ORSO SUBDIVISION, RESUBDIVISION OF

APPLICATION NUMBER 10 DATE May 6, 2010
APPLICANT Orso Subdivision, Resubdivision of
REQUEST Subdivision

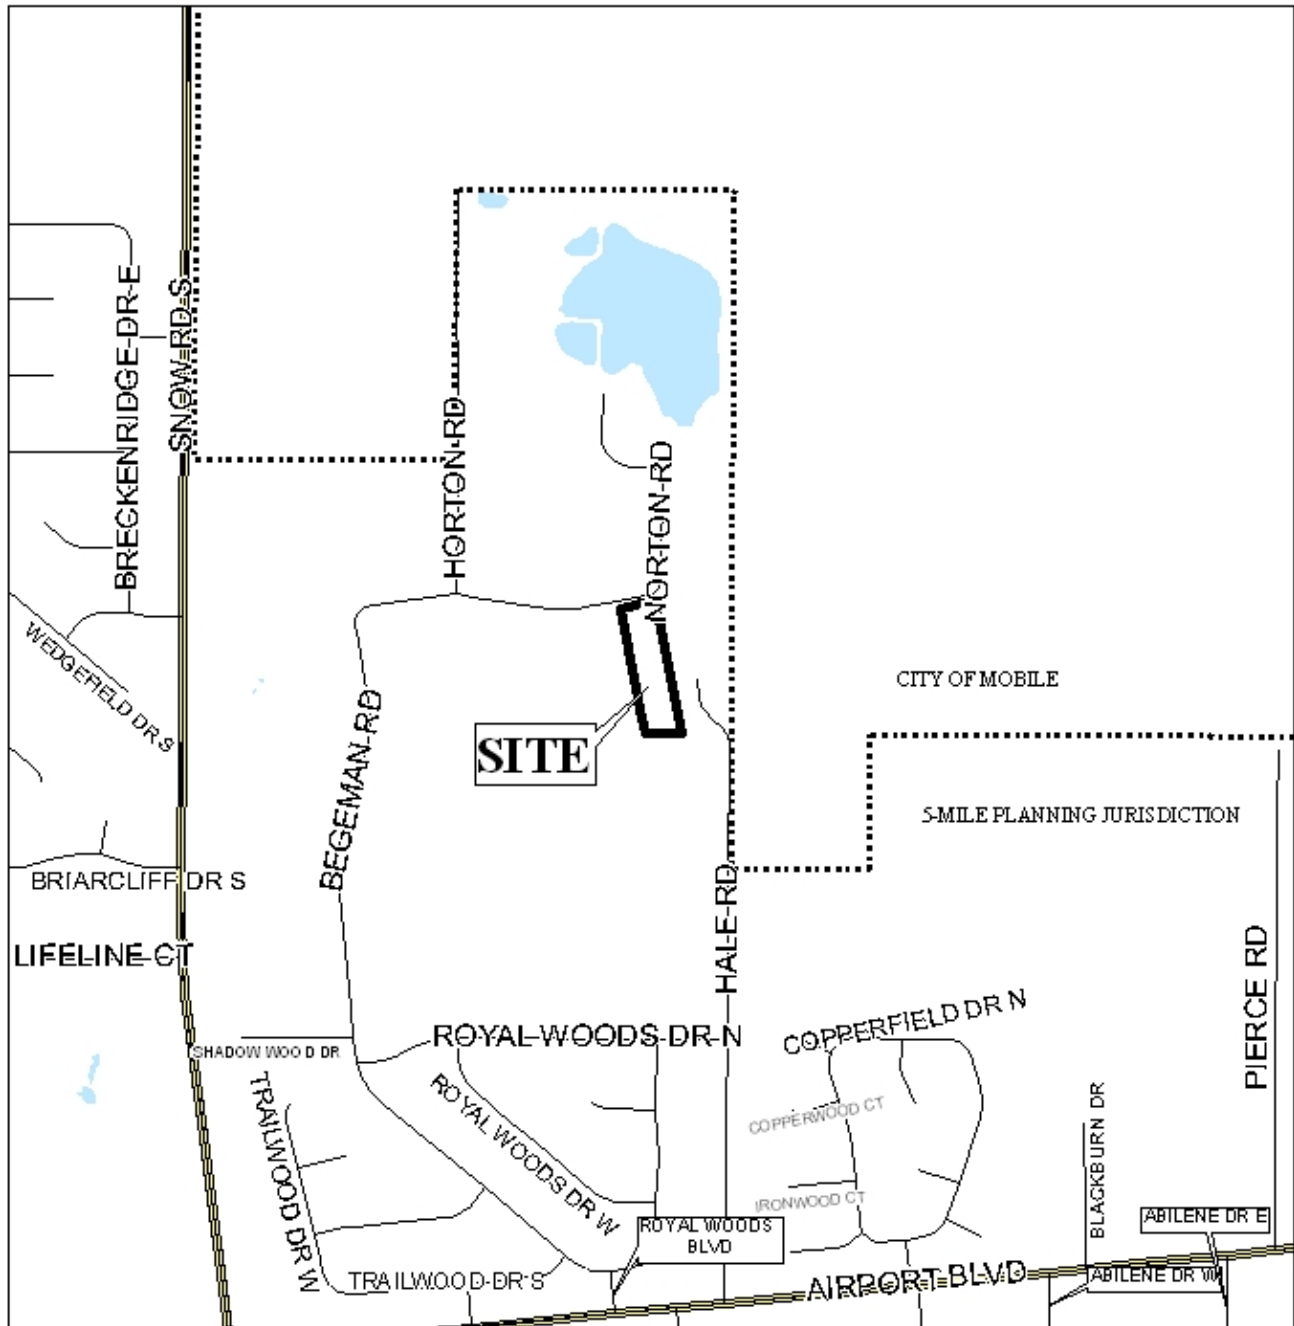
The plat illustrates the proposed 2-lot, 1.9± acre subdivision which is located at 411 Begeman Road (South side of Begeman Road, 150'± West of its East terminus). The applicant states that the subdivision is served by individual wells and individual septic tanks.

The purpose of this application is to resubdivide two existing legal lots of record which were approved by the Planning Commission on July 7, 2005. The applicants propose to move the existing interior lot line 115 feet to the North.

The proposed lots meet the minimum size requirements as regulated by Section V.D.2. of the Subdivision Regulations. The proposed Lot B is currently a flag lot, and, as such, a waiver of Section V.D.1 may be appropriate.

The 25-foot minimum building line is depicted correctly for the proposed Lot A, and should be retained on the Final Plat, if approved. The 25-foot minimum building line should be depicted 25 feet back from where the proposed Lot B opens to its standard width of 177.5 feet. The lot area sizes are depicted in square feet for both lots and should be retained on the Final Plat, if approved.

It should be noted that both of the proposed lots front Begeman Road, a minor street not provided with curb and gutter. Begeman Road is depicted with an adequate right-of-way of 60 feet and, as such, no further dedication would be required. It should be noted that Begeman Road is not currently improved, and, as noted on the previous approval, a note should be placed on the Final Plat, if approved, stating that no further resubdivision shall be permitted until such time as additional frontage on a public right-of-way, built and maintained to County standards is provided.

Aerial photography reveals that the site is currently utilizing two curb cuts, one for each lot. This should be maintained, and a note placed on the Final Plat limiting each lot to one curb cut

each to Begeman Road, with the size, design, and exact location of all curb cuts to be approved by County Engineering and conform to AASHTO standards.

- 1) retention of the labeling of the lot size area, in square feet, on the Final Plat;
- 2) retention of the depiction of the 25-foot minimum building line as shown for Lot A, and modification of the same for Lot B to be depicted where the lot opens to its standard width of 177.5 feet;

- 3) placement of a note on the Final Plat limiting each lot to one curb cut each to Begeman Road, with the size, design, and exact location of all curb cuts to be approved by County Engineering and conform to AASHTO standards;

- 4) placement of a note on the Final Plat stating that no further resubdivision shall be permitted until such time as additional frontage on a public right-of-way, built and maintained to County standards is provided;
